Application Ref: NP/13/0461

Application Type	Full
Grid Ref:	SM85771264
Applicant	Mr & Mrs N & W Davies
Agent	Mr Andrew Vaughan-Harries, Hayston Development & Planning
Proposal	Dormer Cottage
Site Location	Plot 2, Off Blockett Lane, Little Haven, Haverfordwest, Pembrokeshire, SA62 3UH
Case Officer	Vicki Hirst

Summary

**PLOT 2
 PROPOSED SITE LAYOUT PLAN
 SITE AREA = 592 SQ.M.**

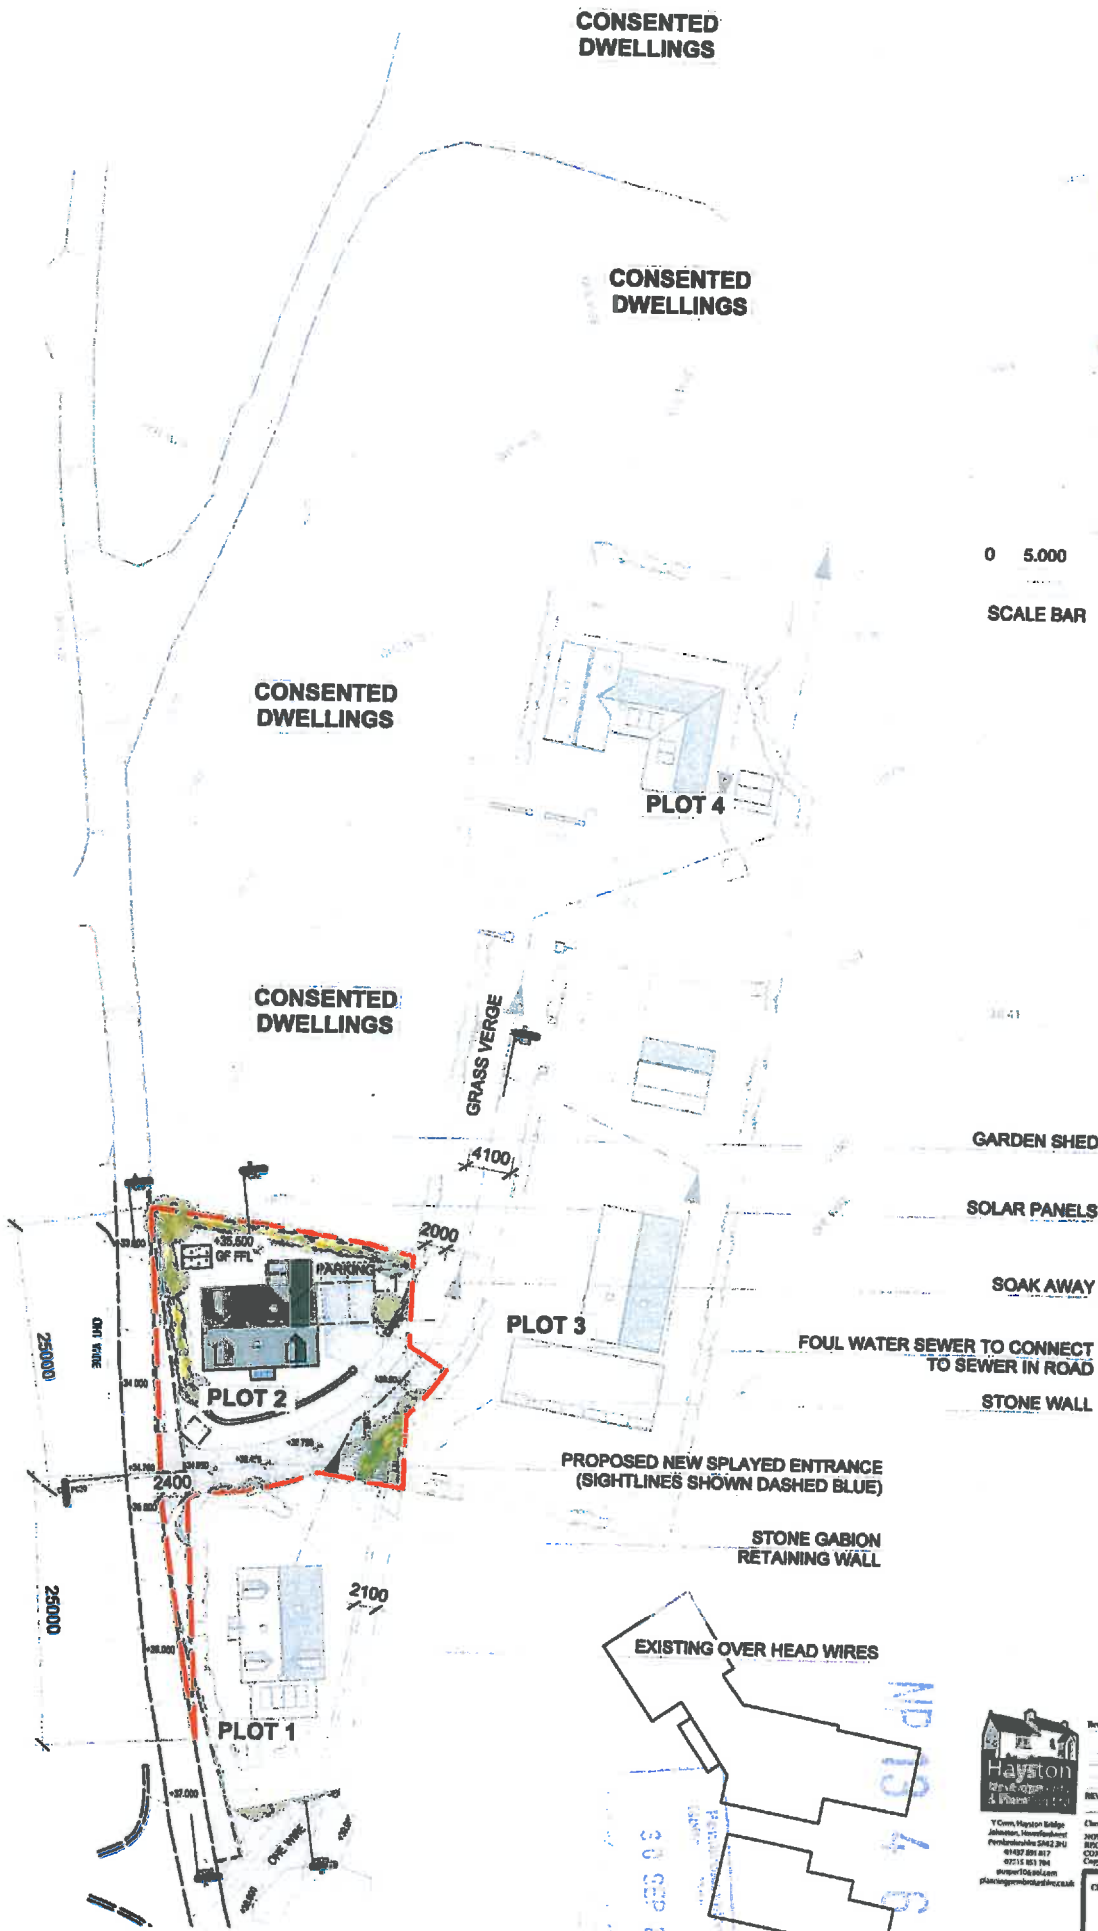
The new access would necessitate the removal of a length of existing hedgerow (which has been retained in the 2010 permission) and substantial excavation and alteration of the banking that the hedgerow is planted upon to facilitate the new access road and required visibility splays. It is your officers' view that the impact of this access, combined with those existing (albeit slightly improved to the south) would be to transform the rural character of Blockett Lane into one dominated by residential development with a succession of accesses coming off it to serve the new and existing development. As a result of the above matters it is felt that the proposal is harmful to the special qualities of the National Park in that it fails to harmonise with the landscape character of the area, and results in the loss of important traditional features. This forms the first reason for refusal.

The elevated location of the site means that it is very visible in the wider landscape, including from the Coast Path. Although the application proposes a new hedgerow to the northern and western boundaries of the site, this is not felt to be sufficient to mitigate the change in character of the area as discussed in the sections above. This is particularly so because of the removal of the existing hedgerow that defines the eastern edge of Blockett Lane. For the reasons discussed above, it is not felt that the proposed landscaping is sufficient to ameliorate the change of character of the area or the loss of the existing hedgerow, or make the environmental improvement requirements of developing this site, contrary to development plan policies.

1. Policies 8, 15, 29 and 30 of the Pembrokeshire Coast National Park Local Development Plan seek to protect and enhance the pattern and diversity of the landscape, prevent development that fails to harmonise with or enhance the landform and landscape character of the National Park, that fails to incorporate important traditional features, and that is insensitively and unsympathetically sited within the landscape and visually intrusive. The proposed access for the dwelling, the resulting loss of existing hedgerow and related banking, and the cumulative impact of existing and the proposed access to the site, results in the loss of a traditional landscape feature and the rural character of the area, and is therefore insensitively and unsympathetically sited within the landscape. Furthermore, the proposed dwelling has limited private amenity space resulting in a cramped appearance at odds with the rural nature of the site. As such the proposal is considered to be harmful to the special qualities of the National Park and contrary to Adopted Development Plan Policy.
